ANNEXURE 2

Urban Design and NSW Apartment Design Guide Assessment

prepared by BHI Architects

Akuna Street, Terralong Street and Shoalhaven Street, Kiama

DERICOPHEN ADAPTATION FLAN I OF 2

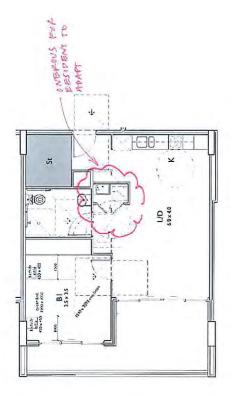
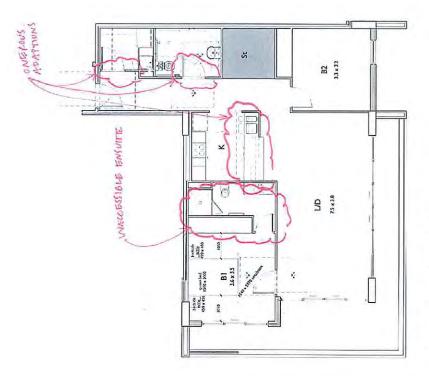
- The adaptable apartment layouts provide an onerous burden on those adapting them to amend layouts at high cost. In one case, an inaccessible ensuite is coupled with an accessible bedroom, potentially making it redundant. More suitable arrangements should be provided.
